A D D E N D U M N O . 1

DETENTION CELLS/DISPATCH RELOCATION
ROCKY HILL POLICE DEPARTMENT
Rocky Hill, CT
KBA #15068.00 – **BID NO. 2016-007**

Date: May 5, 2016
Page: 1 of 3

SKA-1.01

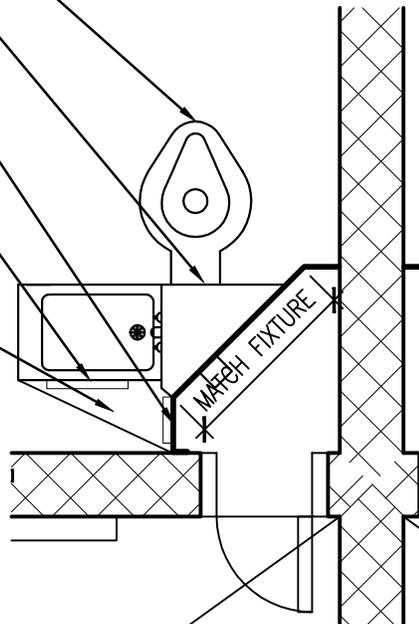
Replace Detail 7 with detail shown in SKA-1.01

HANDICAP DETENTION FIXTURE, TYP.

PICKPROOF CAULK ALL JOINTS, TYP.

STAINLESS STEEL MOUNTING ANGLE
MECHANICALLY FASTENED TO FIXTURE
AND CHASE WALL, TYP.

STAINLESS STEEL ANGLE REINFORCING
FASTENED TO THE ANTI-SUICIDE PLATE,
TYP.

STAINLESS STEEL ANTI-SUICIDE PLATE W/
HEMMED BOTTOM EDGE MECHANICALLY
FASTENED TO THE FIXTURE AND
STAINLESS STEEL CHASE WITH TAMPER
RESISTANT FASTENERS AND 1X1X1/8
ANGLE SUPPORTS (TYP. @ ALL HANDICAP
DETENTION TOILETS)

SKA-1.02

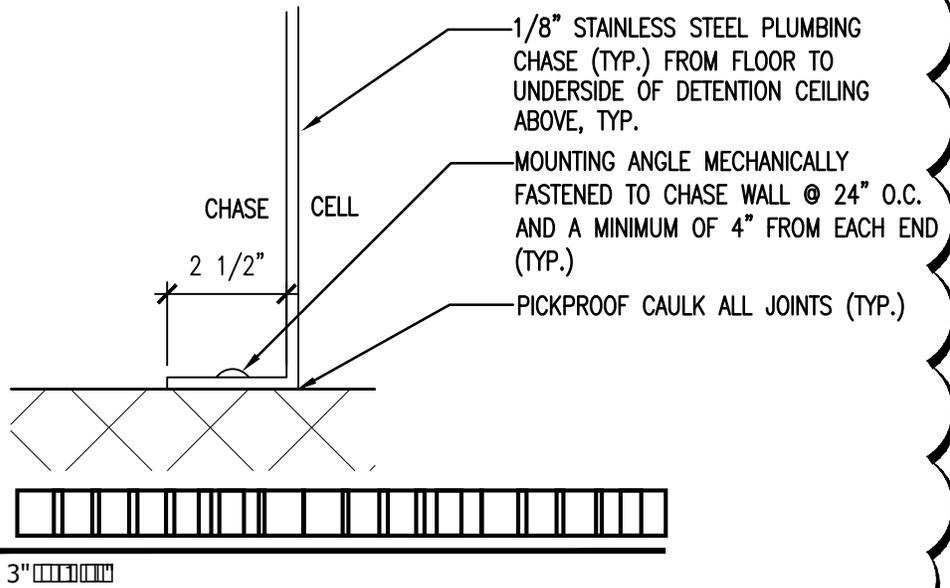
Replace Detail 14 with detail shown in SKA-1.02

3
E4.02A
ALTERNATE #1 POWER RISER DIAGRAM
SCALE: N.T.S.

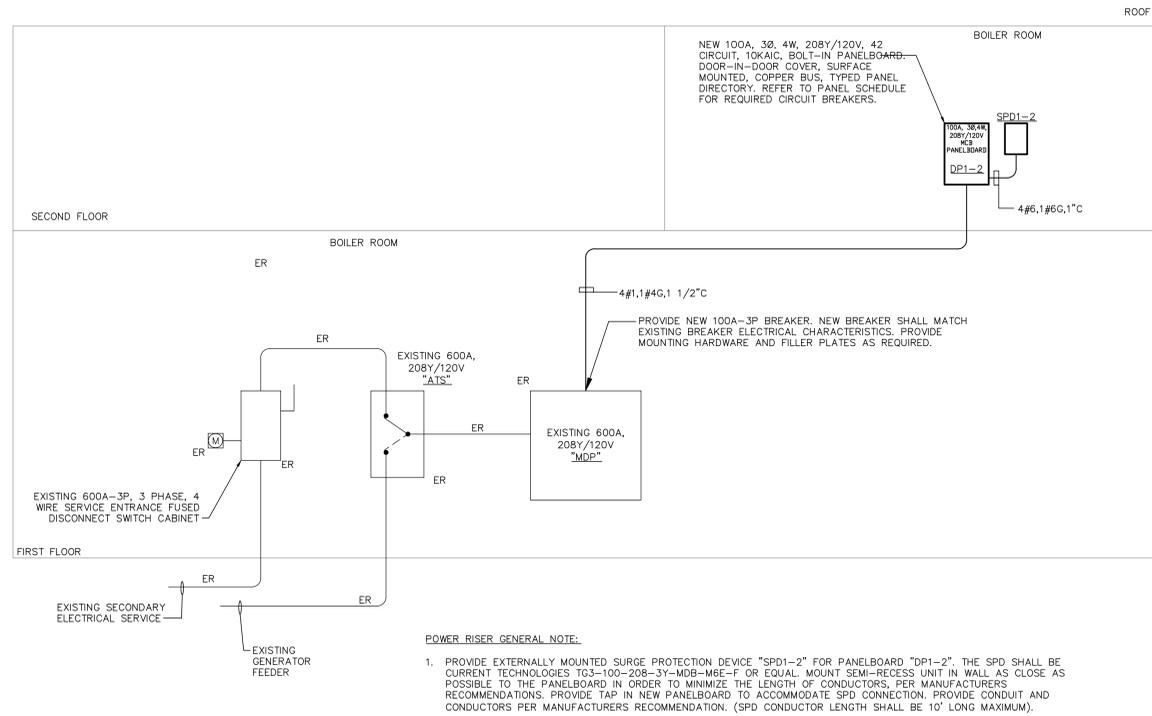
Refer to modified “E4.02A” attached.

2
E4.02A
ALTERNATE #3 POWER RISER DIAGRAM
SCALE: N.T.S.

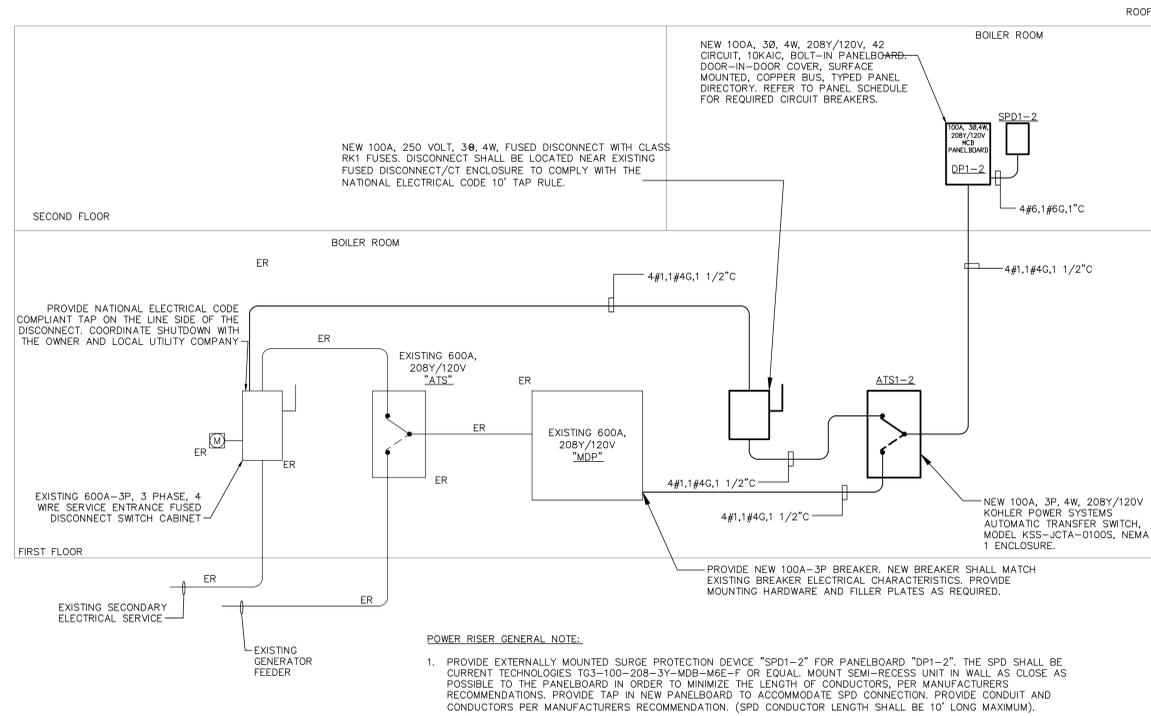
Alternate No. 3: Alternate No. 3 will only be accepted if Alternate No. 1 is also accepted. Add Alternate: Provide all scope of work associated with electrical detail E4.02A/2, which includes a new fused disconnect, Code Compliant tap in the main service disconnect, new Automatic Transfer Switch (ATS), and plumbing scope associated with the water supply relocation. If this alternate is not accepted, but Alternate No. 1 is accepted, the electrical scope included in detail E4.02/3, which includes a new panelboard for the dispatch center fed from the existing “MDP”.

4. Regarding the electrical work in Alternate 1 & 3:
 - a. The Alternate 3 description mentions replacing switchgear if this alternate is accepted, however on drawings E1.03A & E4.02A none of the details indicate replacing any switchgear. Both show running a new feeder from the boiler room to the radio equipment enclosure. They also indicate that as part of Alternate 1 a new transfer switch and disconnect. These do not show up for Alternate 3. The bid from indicates that Alternate 3 is an add, however reviewing the drawings it appears that work is being eliminated which would be a alternate deduct. Please confirm this is correct. If not please clarify what work is Alternate 1 and 3. **SEE ADDENDUM #1**

ADDENDUM #1
